**Ladder Diagrams for Error  
Recovery For FCP -2 Rev 04  
Out-Of-Order Delivery- Annex D**

**T10/00-137r2**

Reference: T11/00-133v1

# Summary of Major Changes

## D.5 Class 3 FCP\_RESP Lost, No FCP\_CONF Req.

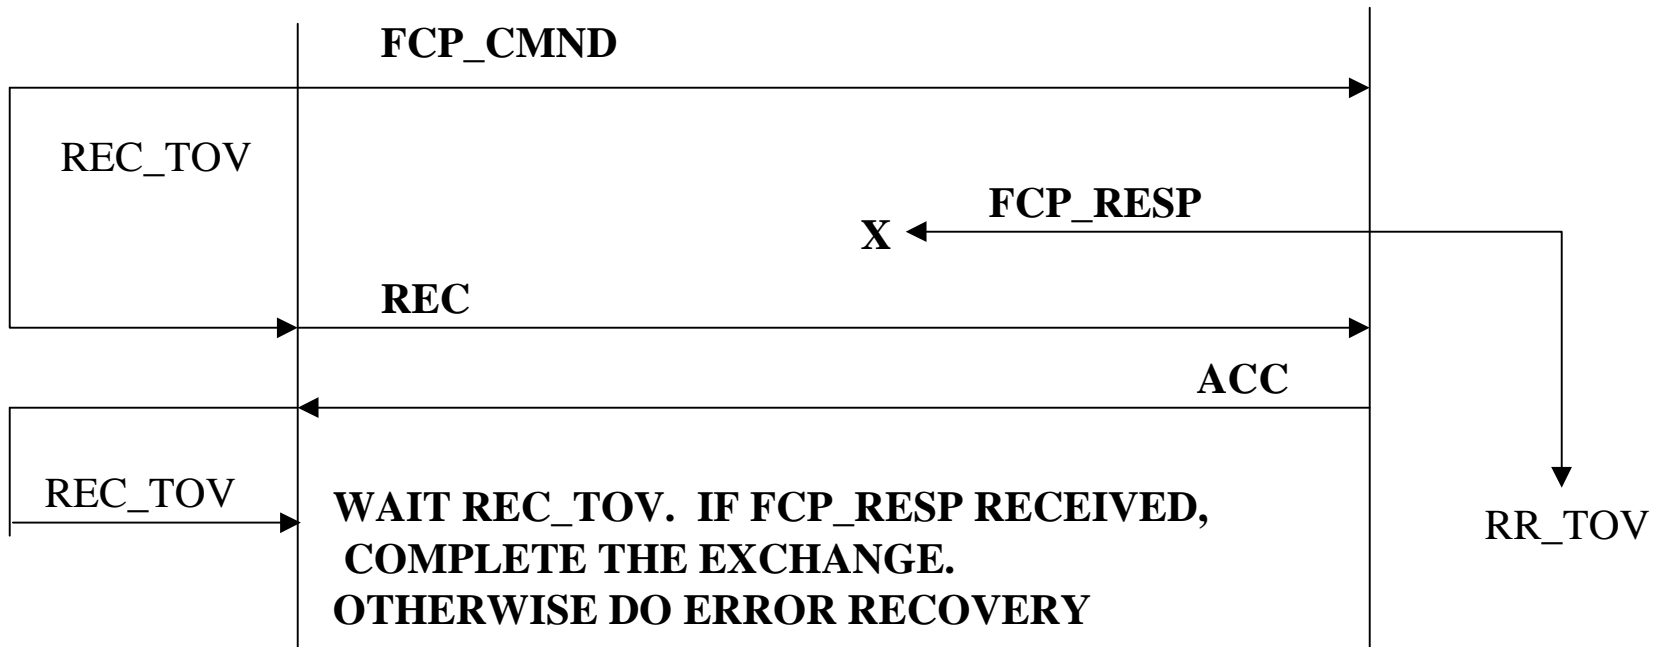
Change to Error Recovery text: The ACC for the REC indicates the Initiator holds Sequence Initiative and the Exchange is **open** for Sequence level recovery and Complete for Exchange level recovery. (It is counter intuitive to restart and Exchange that has been completed.)

# D.7 Class 2 Lost Write Data, Last Frame of Seq.

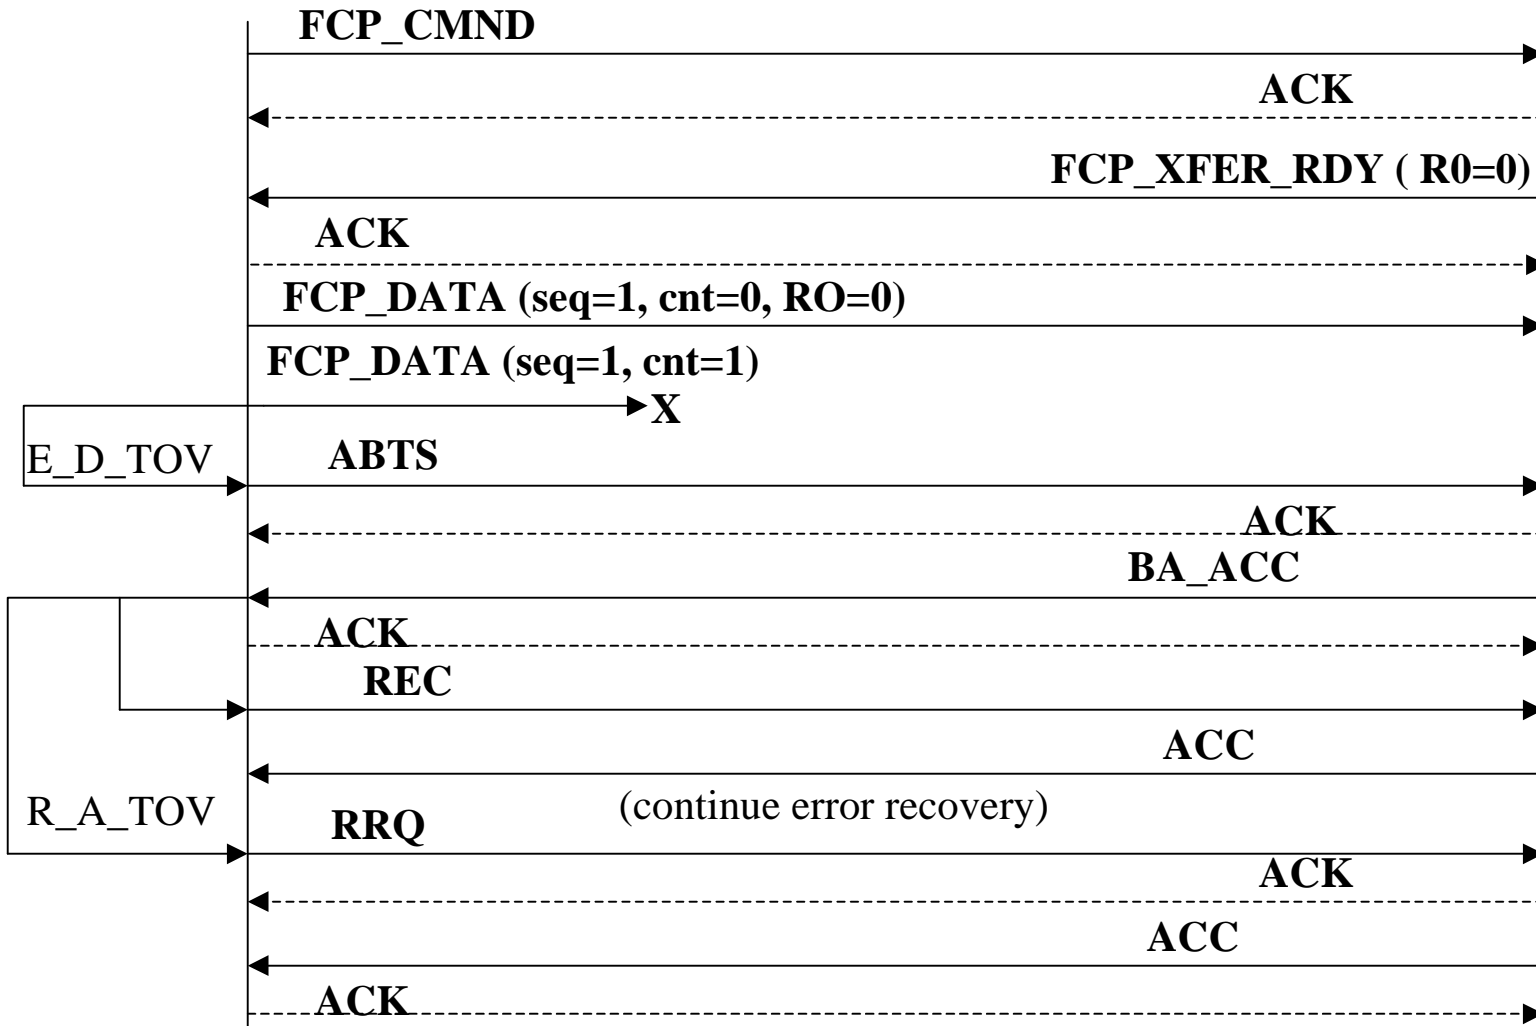
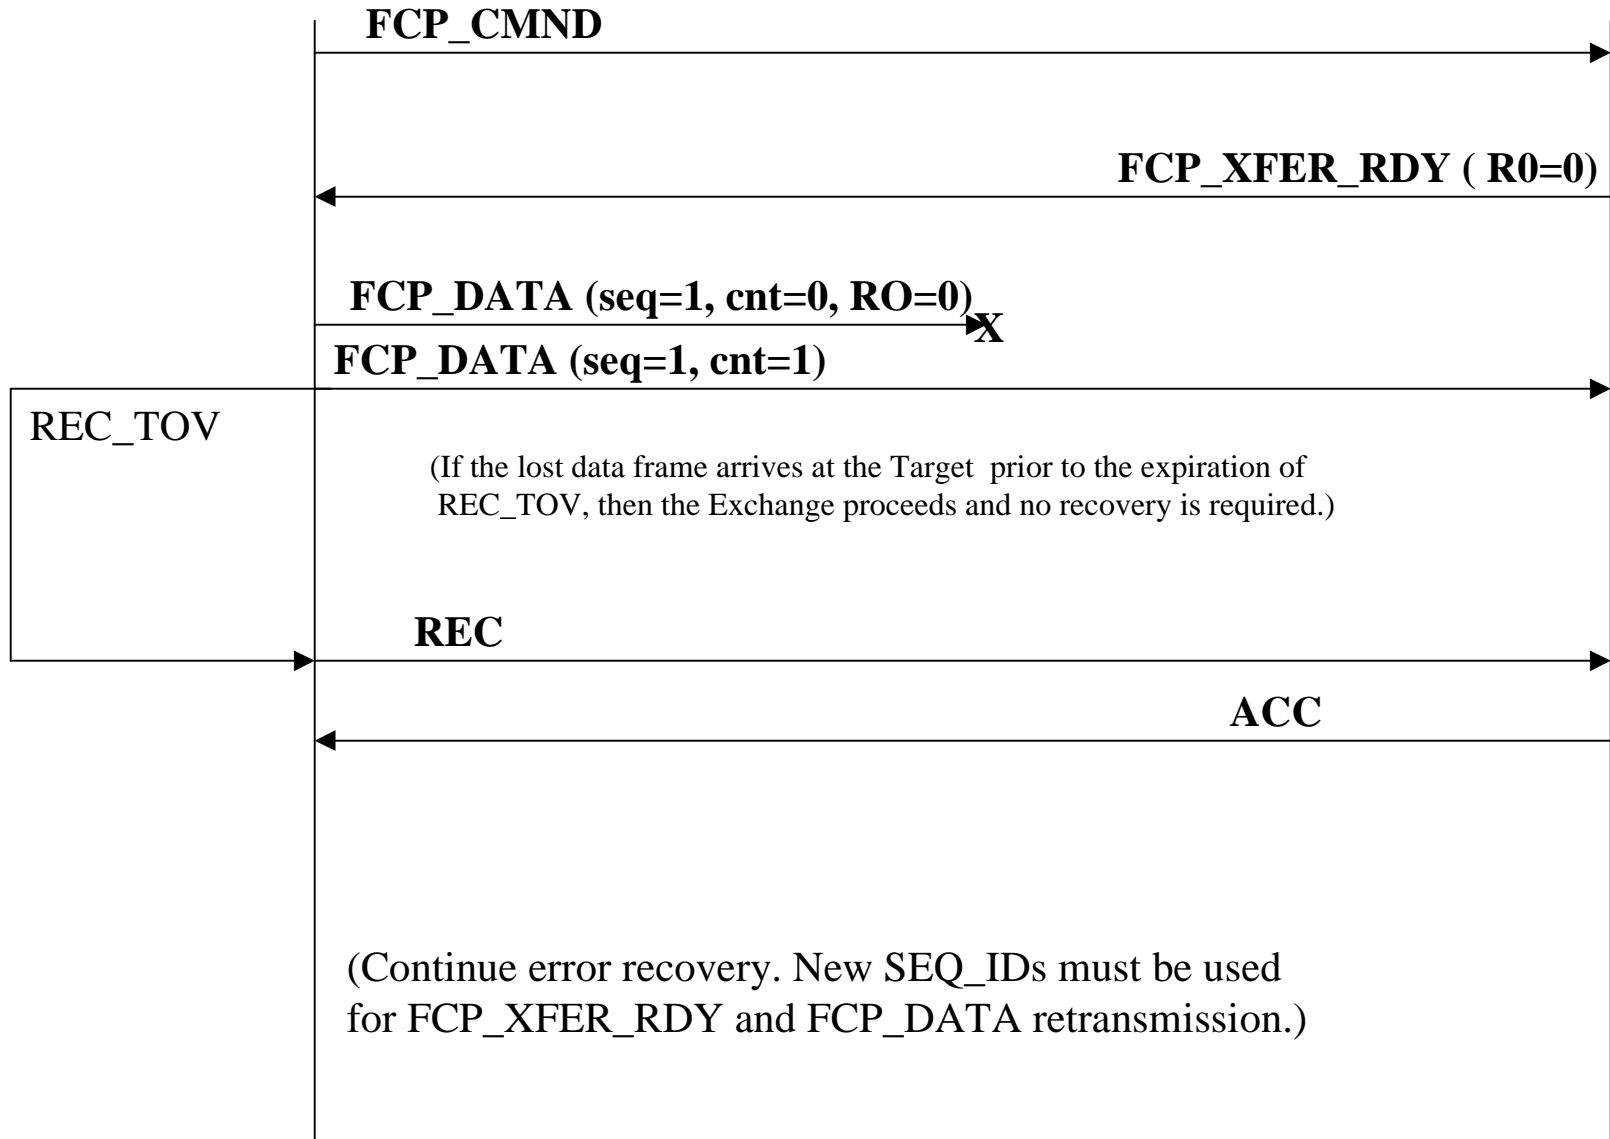
## Error Recovery Addition

BA\_ACC indicates by its payload, that FCP\_DATA Sequence was not completely received (Payload: SEQ\_ID valid, SEQ\_ID value = SEQ\_ID of FCP\_CMND, low SEQ\_CNT of 0 not equal to high SEQ\_CNT of 2). New SEQ\_IDs shall be used for the retransmission of FCP\_XFER\_RDY and FCP\_DATA. For Class 2 the starting SEQ\_CNT value used with FCP\_DATA must one greater than the value used in ABTS. The ACKs for REC/ACC are not shown.

# D.9 Class 2 Lost Read Data, Last Frame of Seq

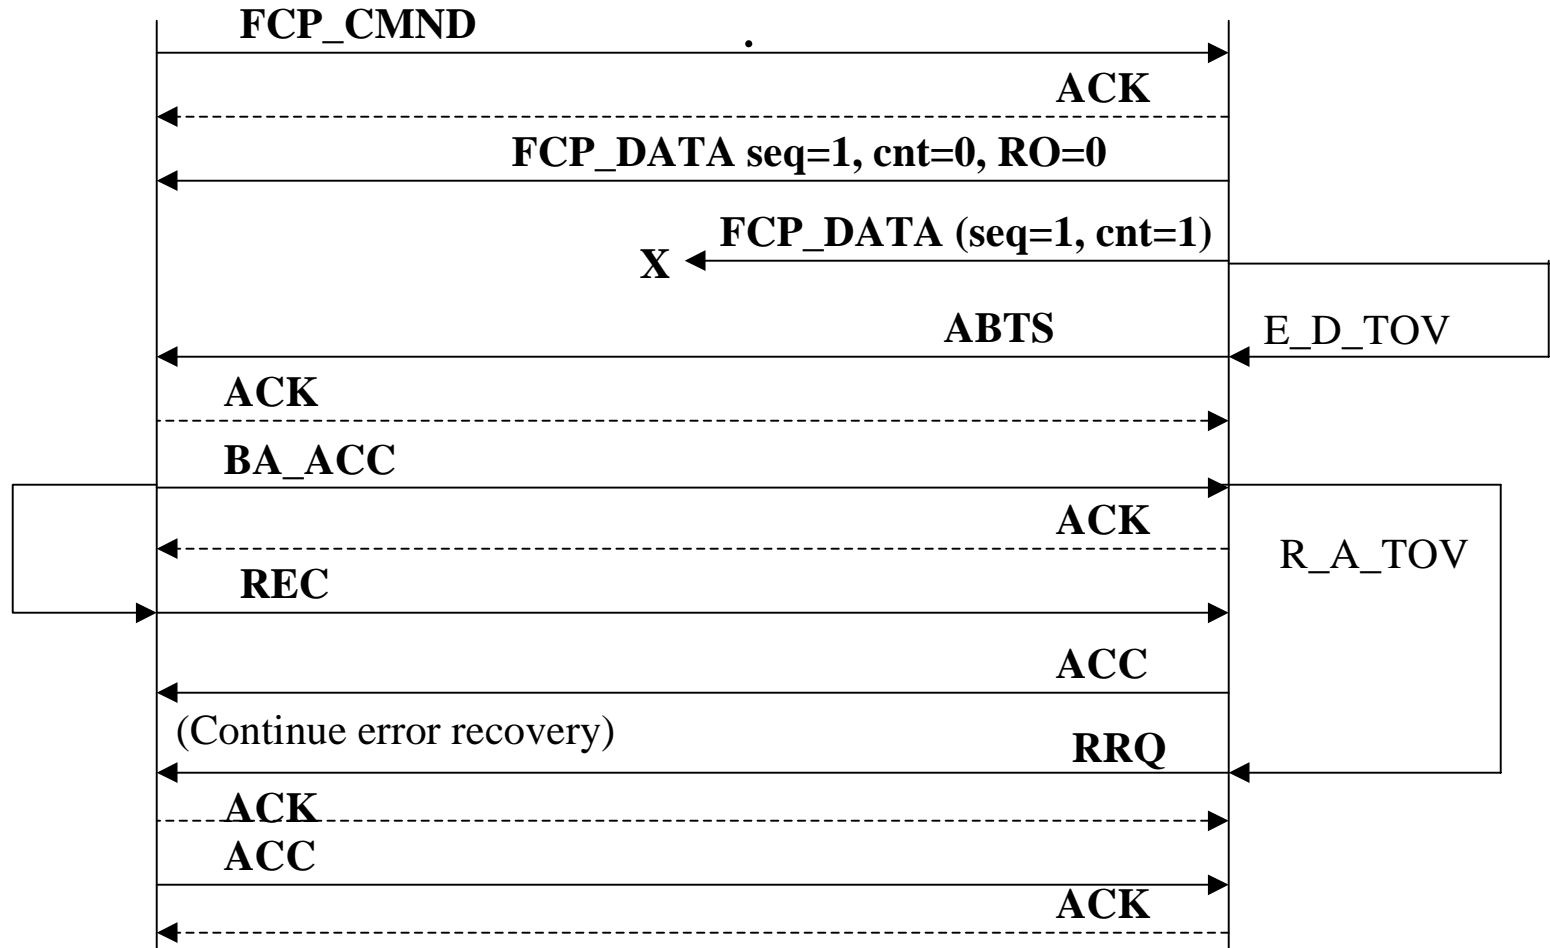
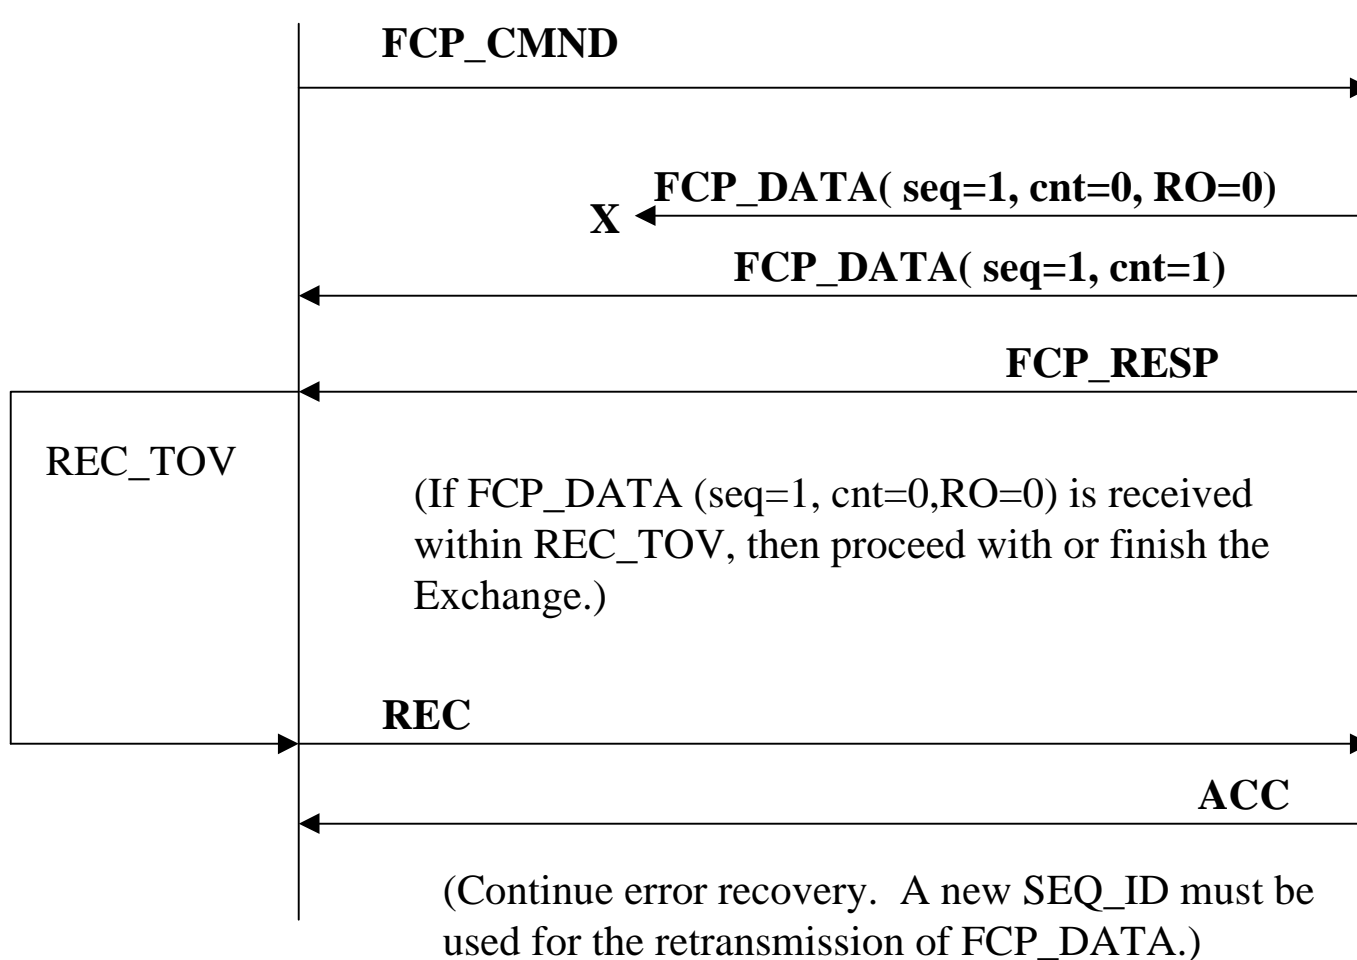
## Error Recovery Addition

BA\_ACC indicates by its payload, that the FCP\_DATA Sequence was not completely received (Payload: SEQ\_ID invalid, low SEQ\_CNT of 0 not equal to high SEQ\_CNT of the ABTS frame of 2).

A new Sequence ID shall be used for retransmission of FCP\_DATA.

For Class 2, the Sequence count value used with the retransmission of FCP\_DATA shall be one greater than the value used in ABTS. The ACKs for REC/ACC are not shown.

# D.13 C1 3, REC Lost

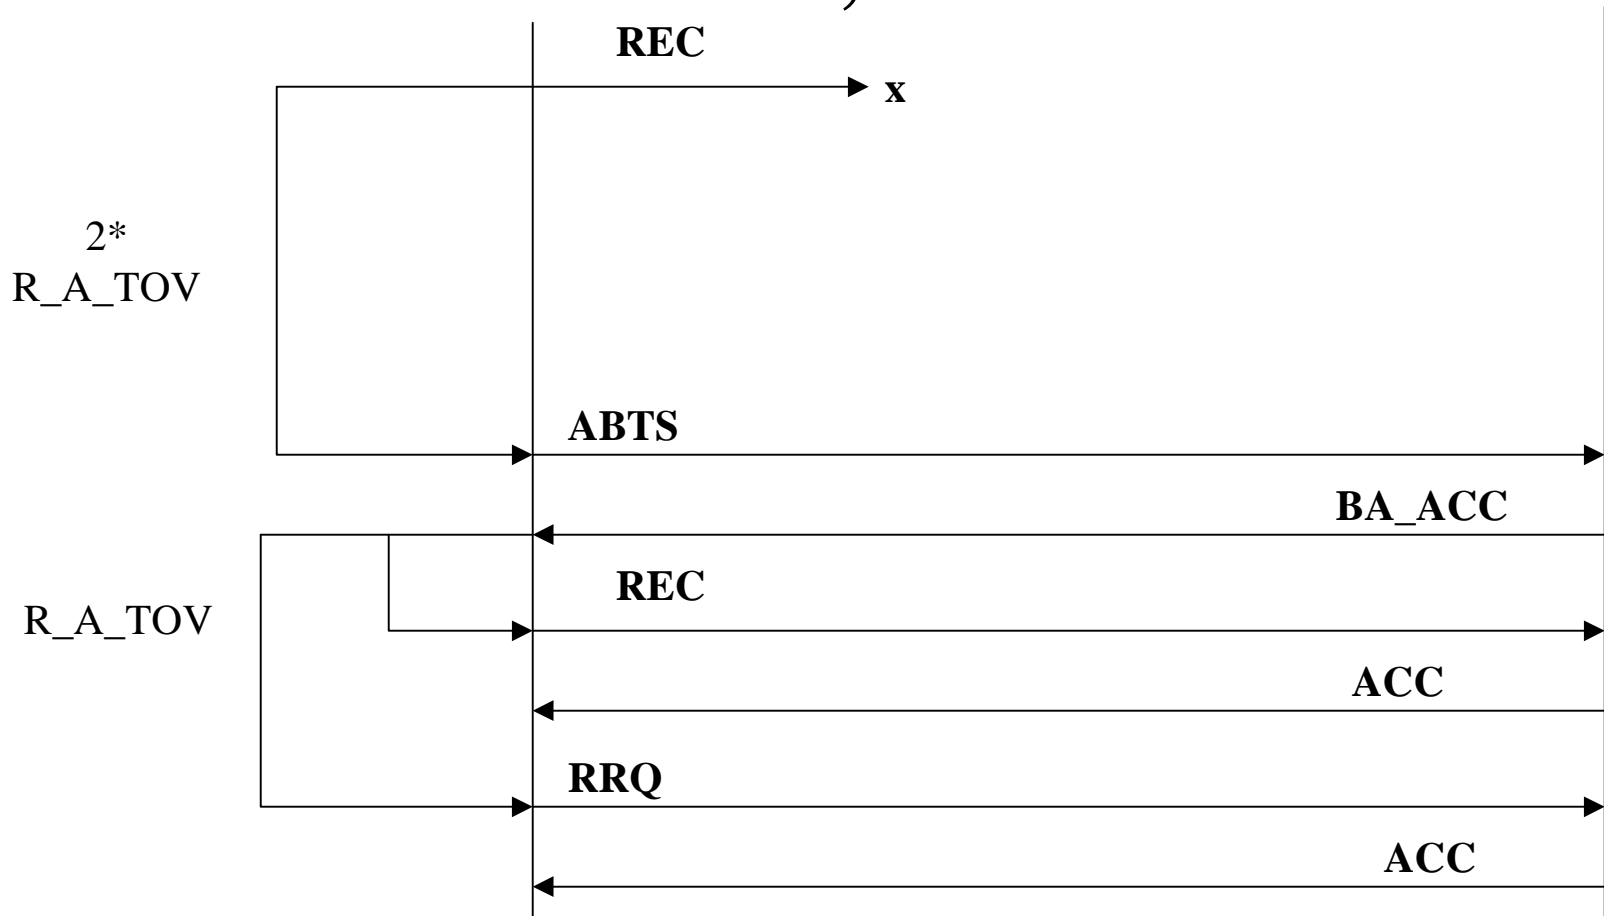
Change E\_D\_TOV in the test to  $2 * R\_A\_TOV$  to agree with the text in 12.6.2

# D.13a C1 3, REC Response Lost

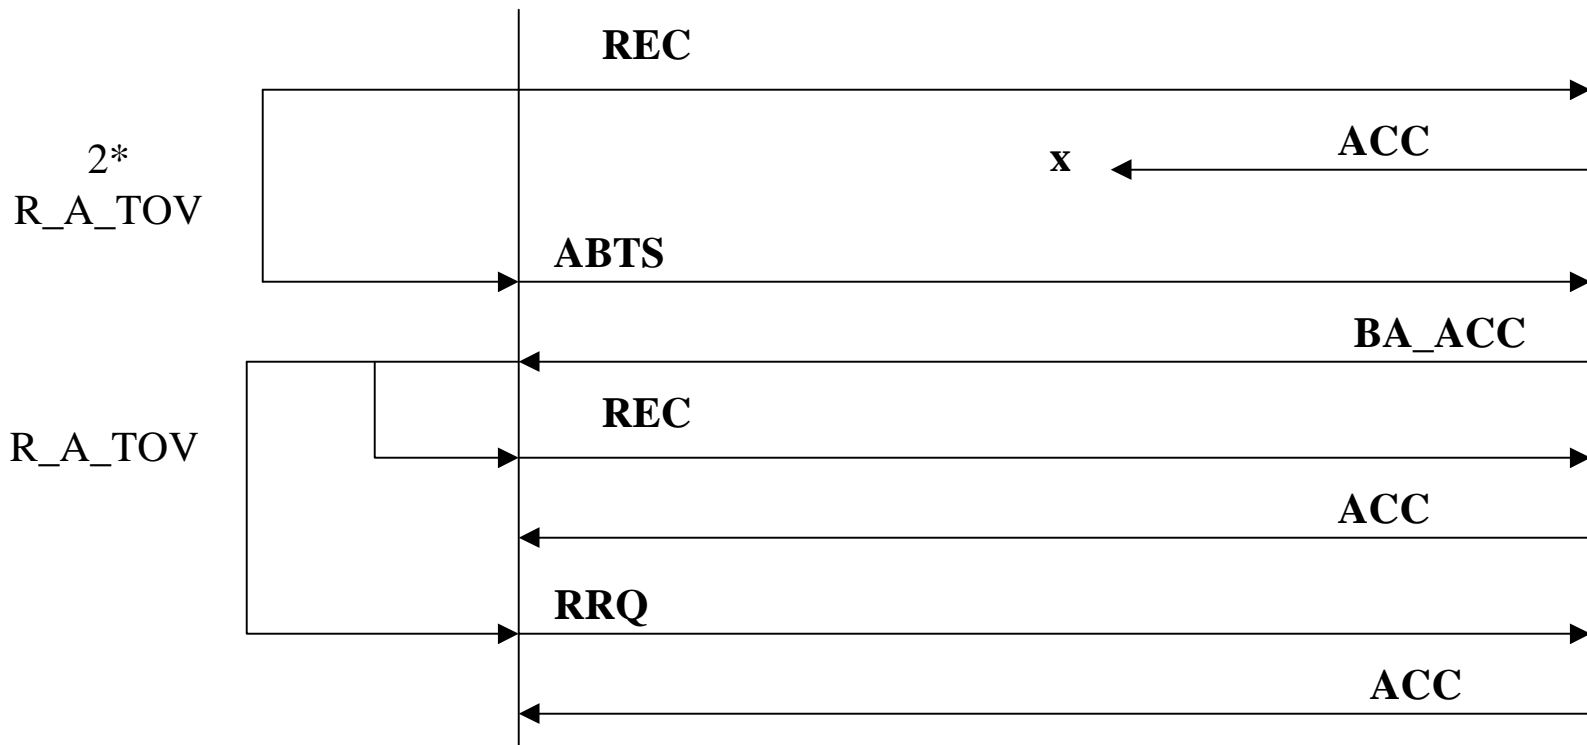
Change E\_D\_TOV in the test to  $2^*R\_A\_TOV$  to agree with the text in 12.6.2

# D.14a Class 3, SRR Lost

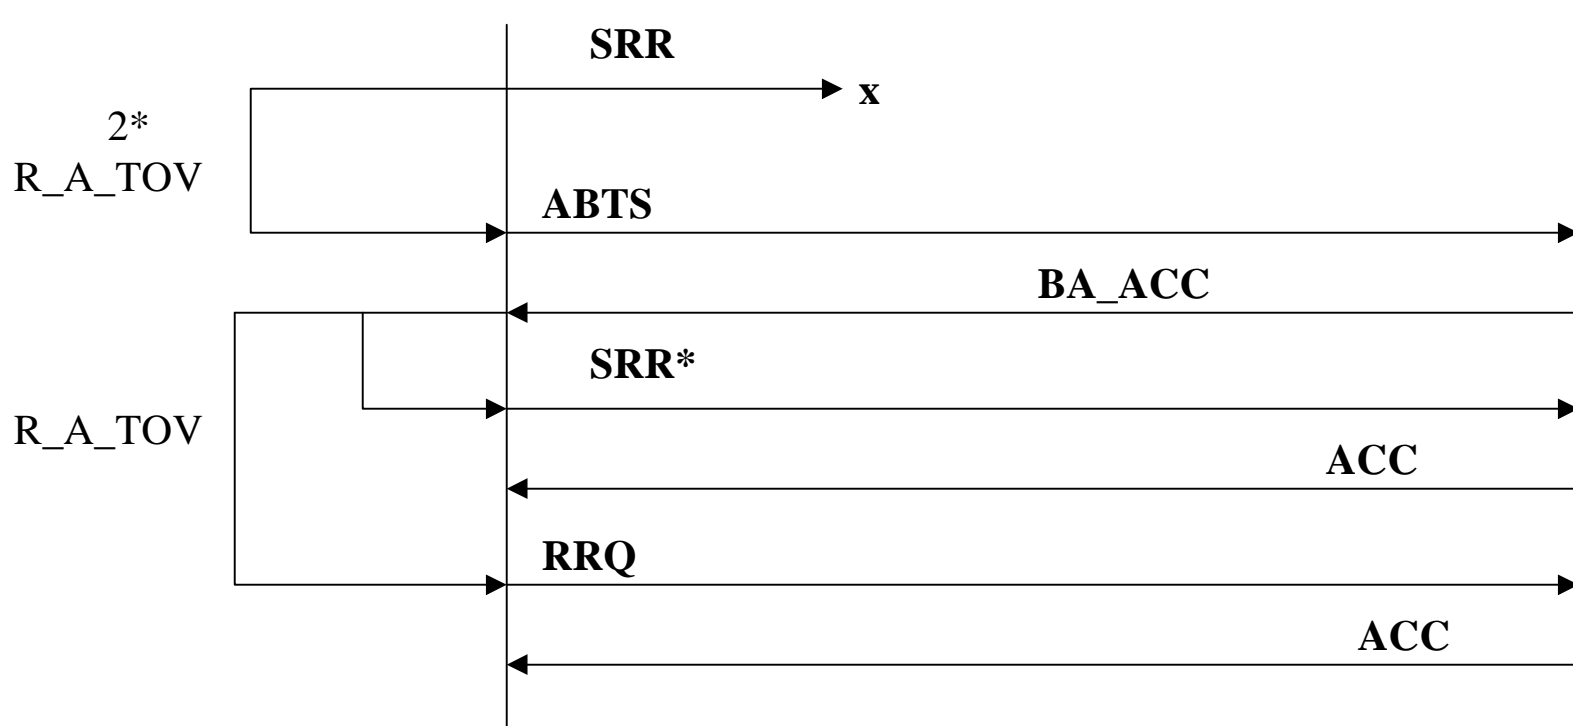
Change E\_D\_TOV in the test to  $2^*R\_A\_TOV$  to agree with the text in 12.6.3
